S/D 96-12 - IVY CHRISTINE ADDITION

RE: Sketch Plat of the Ivy Christine Addition, S/D 96-12, located south of Maple and west of Hoover

STAFF REPORT
(Final Plat, Preliminary Plat Approved 5/9/96)

STAFF REPORT
(Preliminary Plat)

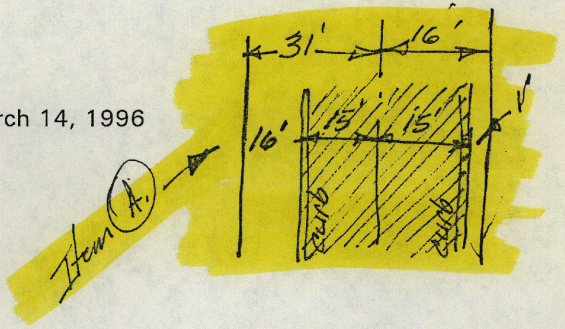
A. While we would not normally accept a plat having a street right-of-way as limited as is being shown for this plat and further with this street creating a double frontage situation for existing platted lots, the unique situation that exists for this strip of property makes it necessary to allow for some leeway in this site's platting.

In order to buffer the existing lots west of this plat's street, the existing row of trees needs to be preserved as fully as possible. Further, because of the limited right-of-way for University Court, parking may need to be prohibited on one if not both sides of this plat. You will need to discuss with City Engineering the actual paving width for this street, and consequently whether parking can be accommodated.

B. The length of this Court is such that a more conventional, circular turnaround needs to be provided. Again, Engineering needs to review with you the possibilities. With a circular cul-de-sac, Lots 3 and 4 would need to be configured in a more typical triangular configuration as is found around such culs-de-sac.

Maple Lane is an existing platted Hammerhead terminating 1320 feet of Street

Proposed University Ct. with a Hammerhead is only 385 feet long.

A 15 foot street, drainage, and utility easement has been added.
